TRANS/WP.29/GRPE/2002/1  
29 October 2001

World Forum for Harmonization of Vehicle Regulations (WP.29)

PROPOSAL FOR DRAFT SUPPLEMENT 3  
TO THE 01 SERIES OF AMENDMENTS TO REGULATION No. 67

(Equipment for liquefied petroleum gas)

Figure 1 - description of the impact test procedure:

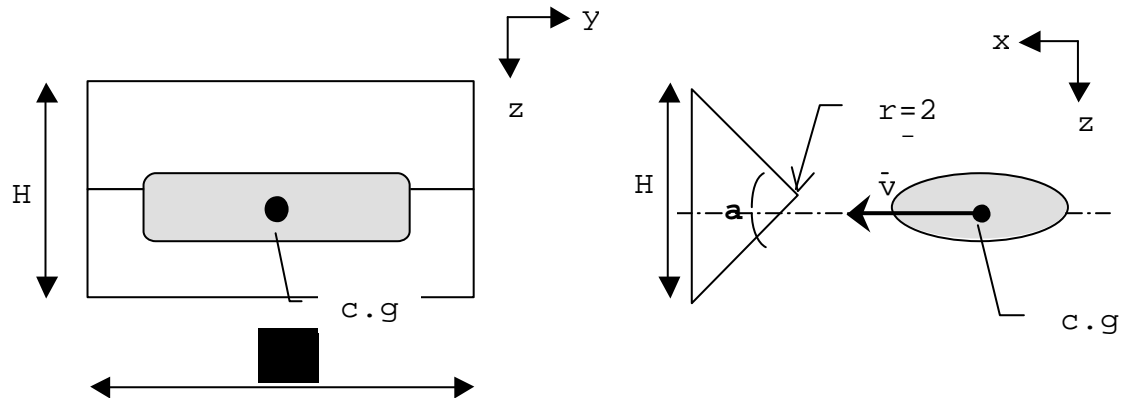
Insert paragraphs 2.7. to 2.11.3., to read:

A container filled with the fluid medium to the weight that equals the filling with 80 % of LPG with a reference mass of 0.568 kg/l, is projected, parallel to the length axle (x-axis in Figure 1) of the vehicle in which it is intended to be fitted at a velocity, V of 50 km/h, against a solid wedge, fixed horizontally, perpendicular to the movement of the container.

The wedge shall be installed so that the centre of gravity (c.g.) of the container hits the centre of the wedge.

The wedge shall have an angle  $\alpha$  of 90 degrees and the point of impact shall be rounded with a maximum radius of 3 mm. The length of the wedge  $L$ , shall be at least equal to the width of the container in respect to its movement during the test. The height  $H$ , of the container shall be at least 600 millimetres
